## HISTORIC AND DESIGN REVIEW COMMISSION

**HDRC CASE NO:** 2022-277  
**ADDRESS:** 214 E CAROLINA ST  
**LEGAL DESCRIPTION:** NCB 2956 BLK 0 LOT 10  
**ZONING:** RM-4, H  
**CITY COUNCIL DIST.:** 1  
**DISTRICT:** Lavaca Historic District  
**APPLICANT:** Guy Chipman III/Guy Chipman Construction LP  
**OWNER:** Barrette & Simone George  
**TYPE OF WORK:** Chimney removal  
**APPLICATION RECEIVED:** May 04, 2022  
**60-DAY REVIEW:** Not applicable due to City Council Emergency Orders  
**CASE MANAGER:** Hannah Leighner  
**REQUEST:**

The applicant is requesting a Certificate of Appropriateness for approval to permanently remove two chimneys.

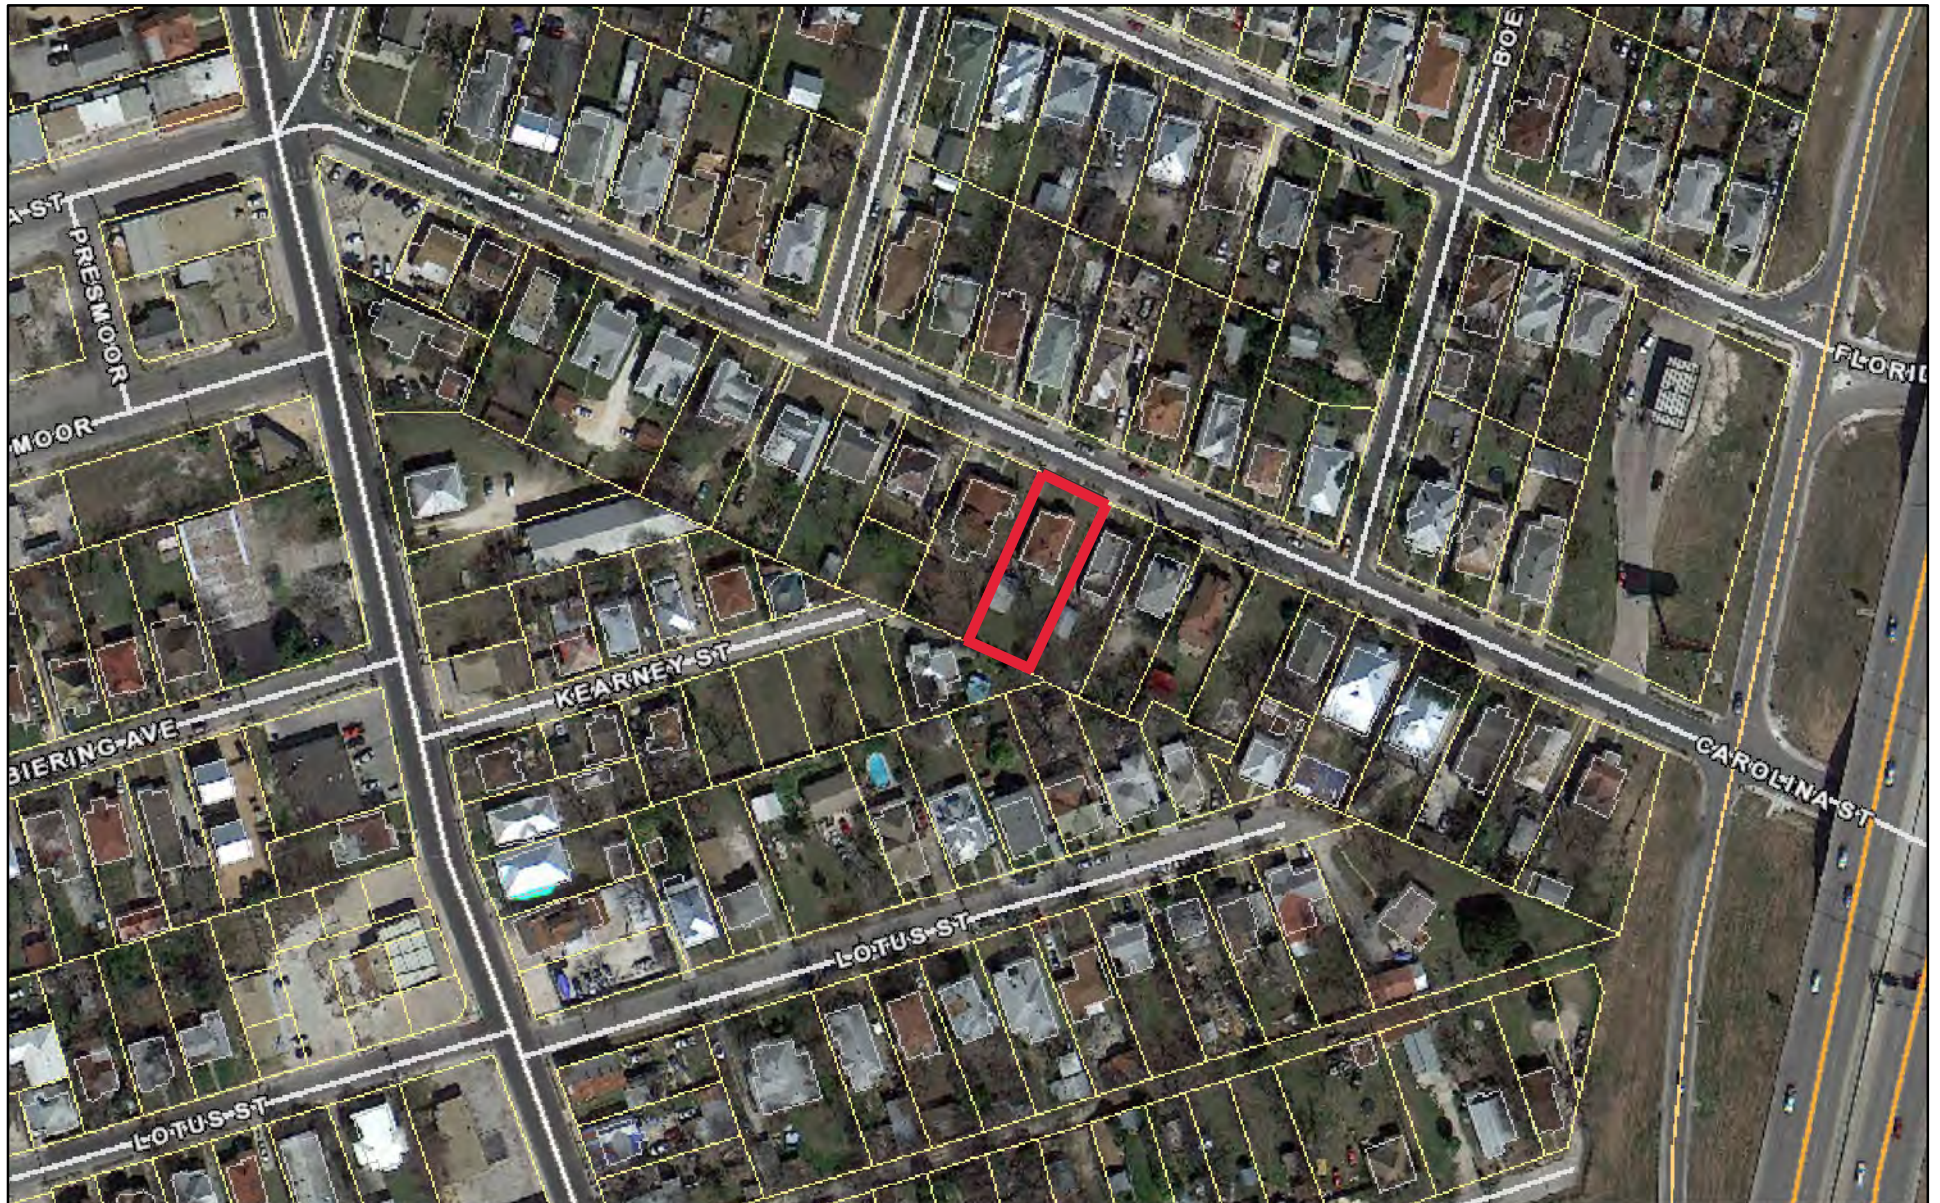
- b. **CHIMNEY REMOVAL** – The applicant has proposed to remove two of the existing chimneys from the historic structure. The front-most chimney will be maintained. The Historic Design Guidelines 3.B.iii state that existing historic roof forms should be maintained. Staff finds the removal of the chimney to be inconsistent with the Guidelines.

- c. **CONDITION ASSESSMENT** – The applicant has provided a structural engineer’s letter for the assessment of the structural integrity of the chimneys requested to be removed. The applicant has also provided photo documentation of the ceiling interior which is beginning to bulge in response to the weight and degradation of the makeshift support for the brick chimneys. As stated in the letter, the two rear chimneys are not adequately supported internally in the attic space, which has resulted in interior damage and leaning of the chimneys in the roof. This assessment advises removal of the chimneys to avoid imminent damage to the structure, and that reconstruction can be accomplished following remedial work to adequately support the features. Staff finds the temporary removal of the chimneys and reconstruction to be most appropriate as an effort to preserve the whole of the historic structure.

Staff does not recommend approval of permanent removal based on findings b and c. Staff recommends temporary removal, structural reinforcement, and reconstruction consistent with the Guidelines.
